Data Sheet Specification Correction for Intersil ZL6105ALAF* Products

**Refer to:
PA12097**

Date: December 21, 2012

Old POD L36.6x6A – PA12097

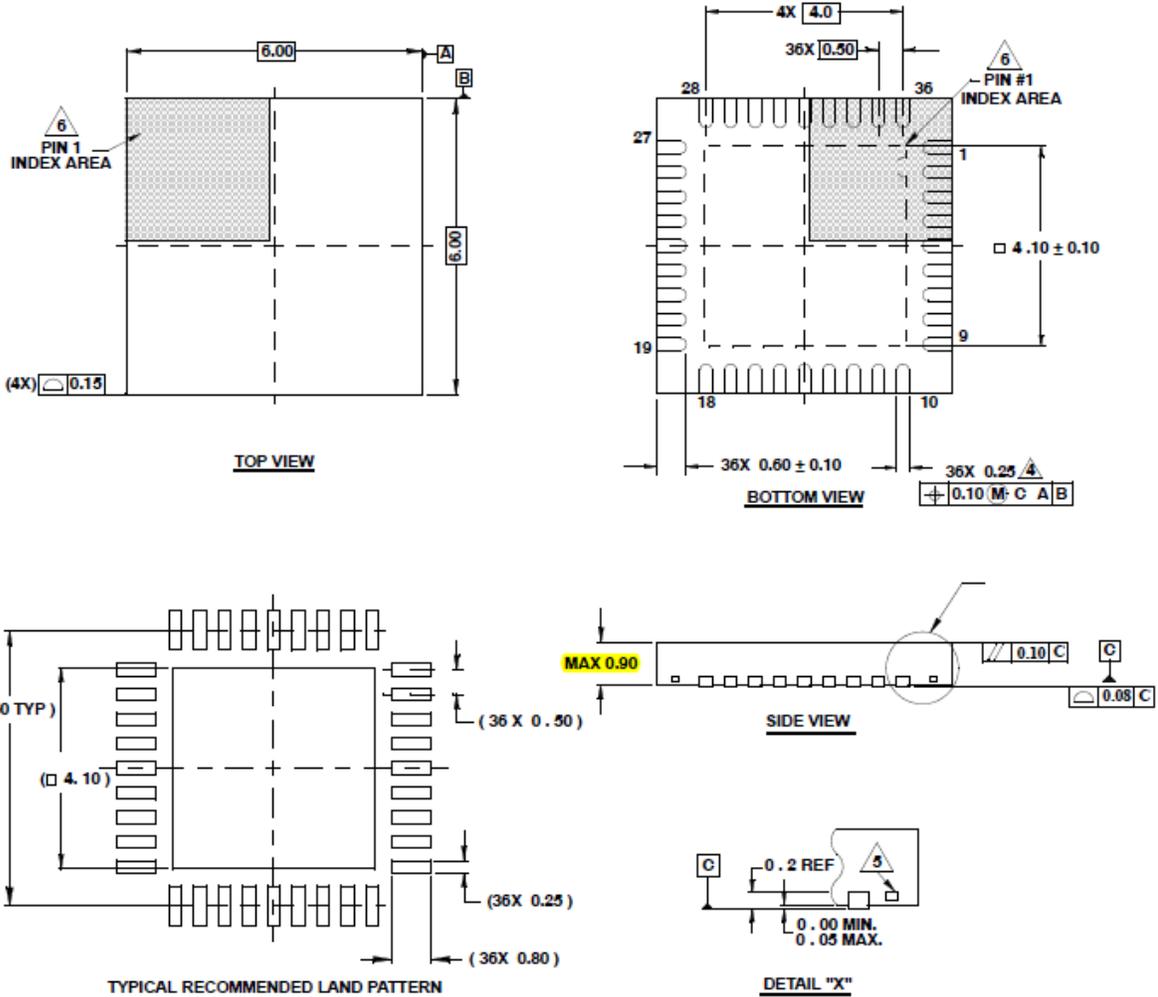
This advisory is to inform you that Intersil has made corrections to the POD (Package Outline Drawing) referenced in the data sheet specification for the ZL6105ALAF* products. The updates to the POD correct the thickness (height) of the package body. The old and new PODs are contained on following pages. There have been no changes to the package or product itself. The updated data sheet is available on the Intersil web site at <http://www.intersil.com/content/dam/Intersil/documents/fn69/fn6906.pdf>.
